## SUPPLEMENTAL INFORMATION #1

Re: Riverbar Lavendar Farm, LLC; Conditional Use Permit

Record Number: PLN-2019-15779 Application Number: 15779

- Revised Road Evaluation prepared by CE Chapman Engineering dated August 19, 2020.
   The applicant had previously submitted a Road Evaluation with turnouts proposed on locations that has showed to be problematic with the community. With consultation with Public Works, the applicant has revised the Road Evaluation to use a preexisting turnout across the applicants parcel and have a new turnout to be located at the new driveway, servicing the parcel.
- 2. Revised ATTACHMENT 1 RECOMMENDED CONDITIONS OF APPROVAL, item number 2. The applicant is to adhere to the Road Evaluation report prepared by Chapman Engineering, dated August 19, 2020.

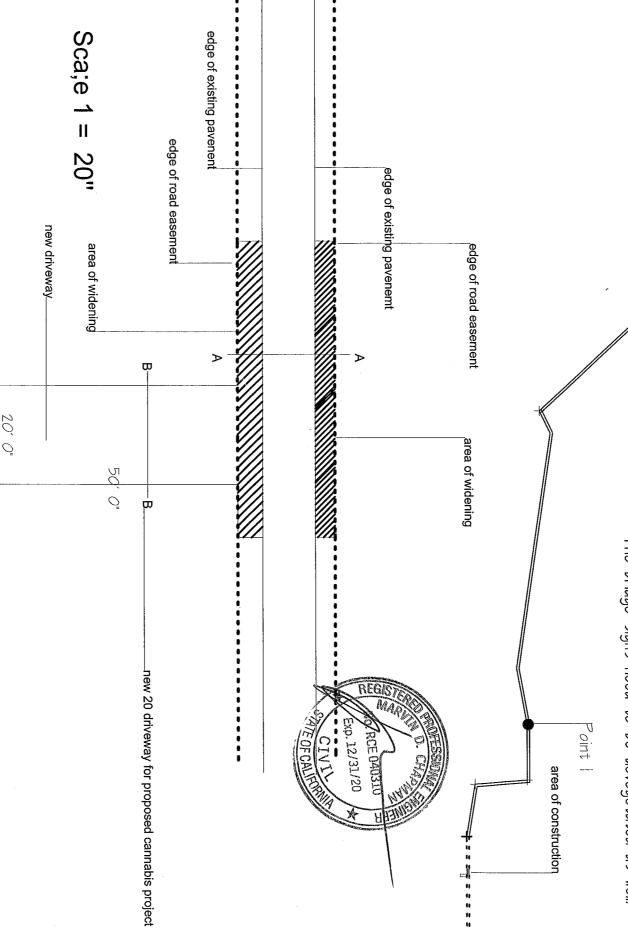
Road is constructed within a 20' wide R Road is generally paved approximately 15' with occasional areas that are narrower ROW

distinctly not Category 4, nor is it feasible it up to a Category 4 road.

trucks which The primary problematic traffic is the gravel truck traffic from the gravel operation farther out the road. The day I was out there I passed two grave trucks which had pulled over to allow traffic going the other way to pass. two gravel

The only improvements I would recommend would bre posting the first portion of the road with a speed limit of twenty five miles per hour and the portion after point I with a speed limit of fifteen miles

narrow bridge

The bridge signs need to be devegetated as well.

The property owners along River Bar Rd are not copperating with the previously submitted road evaluation. A revised road evaluation has been to use two turnouts along River Bar Rd These turnouts include a preexisting turnout at Riverbar Pharms and a new trunout to be at the location of the new driveway to serve AP # 204-331-019
